MILBANK
ENERGY AT WORK

2020 National Electric Code (NEC) Changes and Milbank Products

Left: Illustration from International Association of Electrical Inspectors (IAEI) for Section 230.85
Right: Milbank label used on relevant meter mains to be compliant with Section 230.85

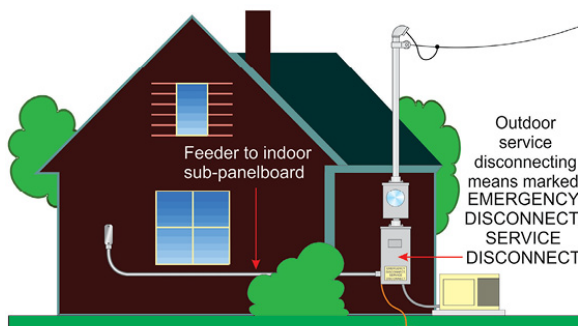
There are several approaches that manufacturers are employing to solve this. The first option is to install a disconnect switch separately from the meter socket. This approach will comply with Section 230.85, and single position meter sockets such as a Milbank U7040 will work for service equipment. This is not the preferred installation method because it requires multiple boxes on the exterior of the building and multiple connections.

For situations where a separate disconnecting means is not preferred, the disconnecting means can be inside the meter enclosure. Milbank has many meter main products that meet this requirement. We have added the Section 230.85 code-required markings to all meter main products and Milbank meter mains are 100% compliant with Section 230.85.

**EMERGENCY DISCONNECT,
SERVICE DISCONNECT**
**DESCONEXION DE EMERGENCIA,
DESCONEXION DE SERVICIO**

Aluminum bus with snap in barrier

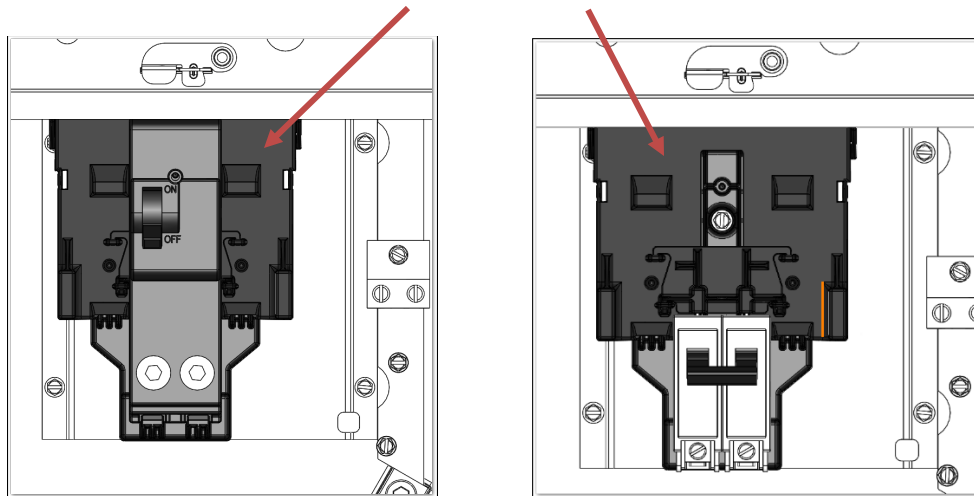
Milbank meter mains will be the primary product line impacted by Section 230.62. Our meter mains have either bus or wires that connect the metering section of the unit to the breaker. The metering section is separated by a sealed front and a metal barrier. However, the barrier and, sometimes a raceway, can provide larger openings than those allowed by the “probe” inspection of UL’s panelboard standard, UL 67.

Milbank has multiple solutions in place to comply with Section 230.62 and have already implemented many of them. For example, on products containing a Siemens QN breaker fed by wires, the breaker’s set screws were filled with a compliant plug, and factory processes were modified to control wire insulation stripping. This change protected all live parts on the line side of the circuit breaker from contact, ensuring full compliance.

For meter mains that use our aluminum bus, we have designed molded plastic parts to snap into place on top of the bus and another separate part that snaps into the opening in the center barrier. This solution ensures that the bus and opening are completely isolated.

3990 with sheet metal barrier

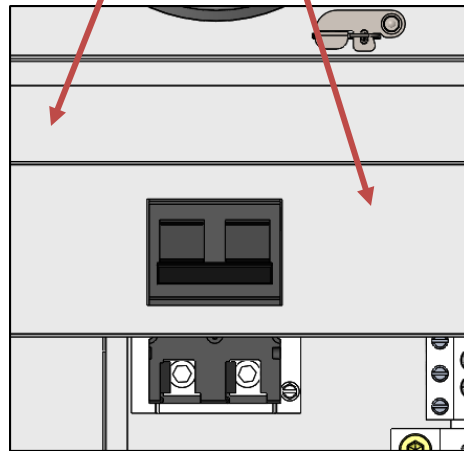
We have various meter mains that use the Milbank large frame breaker design that are either bussed or wired into the breaker from the meter section. Due to the wide variety of designs, and many unique requirements of our customers, Milbank has come up with several possible solutions that mainly involve using formed Formex™ insulators. These insulators cover live parts or an extended sheet metal barrier underneath the deadfront. The sheet metal barrier solution works well in situations where there is a raceway and the opening to the raceway needs to be covered to prevent inadvertent contact.

U6124 with separate compartments for each service disconnect

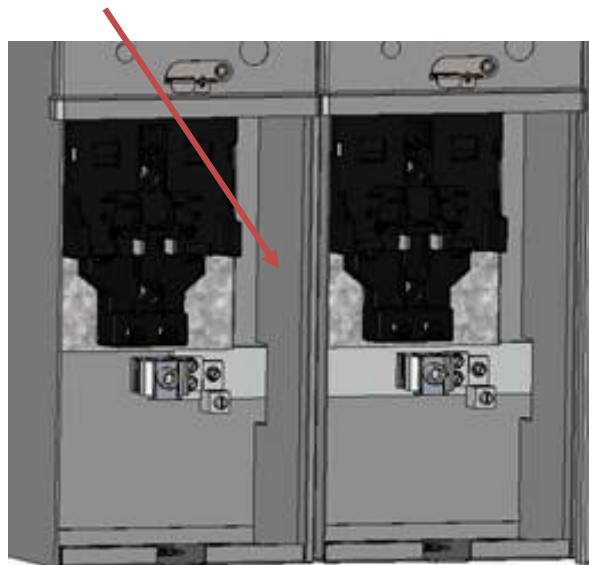
NEC 2020 Section 230.71(B) involves the implementation of separate compartments and barriers that isolate each disconnect from the others and provides protection from incidental contact of live parts when servicing an individual compartment.

Milbank horizontal meter mains will have sheet metal dividers installed that go the entire depth of the metering center, from front to back, to provide the “compartment” for each section that the code requires.
